20 June 2016

Response to Submissions - State Significant Development Application and Variation of the Sydney Cove Redevelopment Scheme for the “*Remediation, Renewal and Adaptive Re-Use of Campbell's Stores*”, The Rocks (SSD 7056)

Extract from the Campbell's Stores Visual Impact Assessment (VIA), view looking east from Hickson Road. The applicant needs to prepare an assessment based on the no development scheme. (Source: Figure 43, VIA, Urbis May 2016).

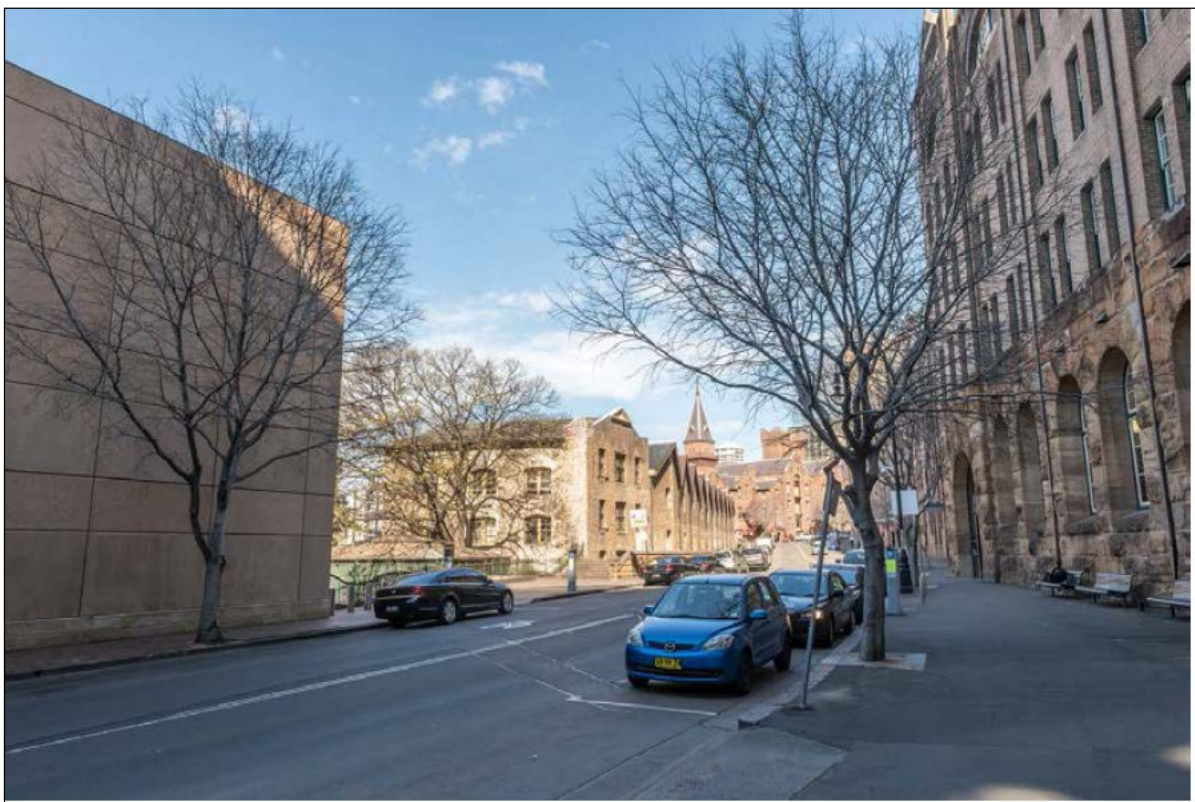
- The images on page three overleaf clearly indicate the benefits of a 'no development option'.
- The applicant fails to provide any further information about the status of any planning or building approval for the existing single storey pavilion to the north of Bay 11. This may, in fact, be an illegal addition that has evolved over time. It is the owners' view that what started as an ephemeral addition has now become permanent. This appears to have been done without building and development approval and, significantly, it impinges on the space needed to provide the physical setting for Campbell's Stores and the community's appreciation of its historical form and function.

Extract from the VIA, view looking south west from Hickson Road. This image illustrates the lost opportunity of the no development option to the north of the Stores that would enable the public to actually see the Campbell's Stores northern elevation and to deliver the full heritage curtilage. (Source: Figure 40, VIA Urbis May 2016). Note that the removal of the inappropriate tree and pavilion would fully expose the Stores' northern elevation.
